Environmental
Protection Agency

September 22, 2011

**Re: Fairfield County Utilities – 6670 Lockville Road, Fairfield County
Permit Number: 4GC03409 *AG**

Fairfield County Utilities - 6670 Lockville Road
Stabilize barren areas
Install erosion controls
Walnut Creek Watershed
September 12, 2011
Photo by: Greg Sanders

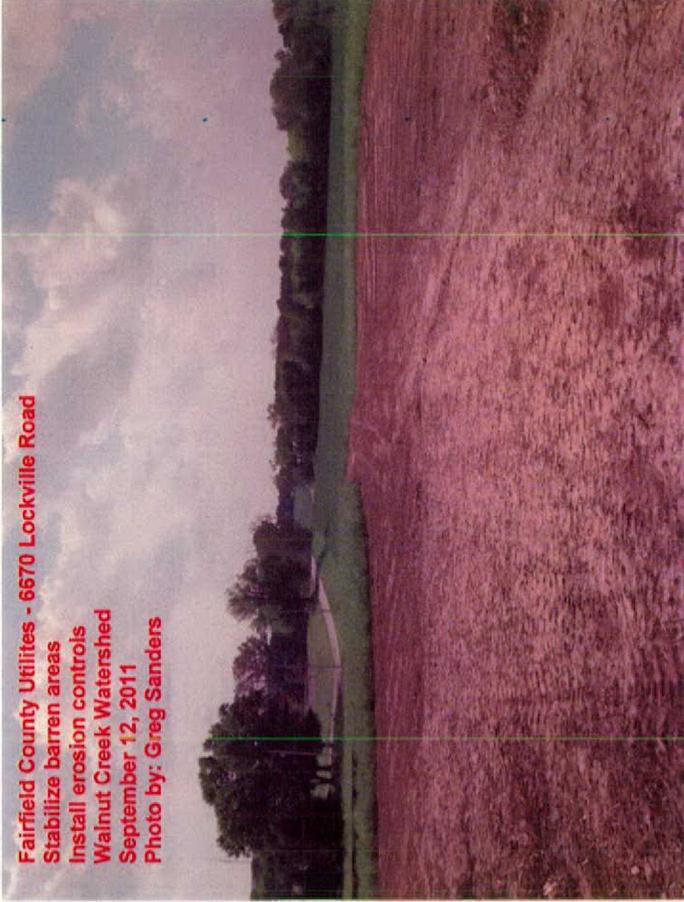
- Please be aware the General Permit states that all barren areas which remain idle in excess of 21 days must be protected from erosion within seven days of the last earth disturbing activities. In addition, erosion protection must be implemented for all areas of final grade within seven (7) days. Please see attached pictures.

- Please install erosion controls around the perimeter of the active building site such as straw waddles or silt fence.
- The General Permit requires the permittee to conduct inspections of all sediment and erosion controls every seven days or within 24 hours of a rain event equal to or greater than 0.5 inches. A log of the inspections and resulting corrective actions must be maintained on site available for review. All earth disturbing activities must be clearly documented in your inspection reports to ensure the temporary or permanent stabilization requirements are not violated. Please e-mail me a copy of the last two months of the inspection logs to my e-mail address at greg.sanders@epa.ohio.gov.
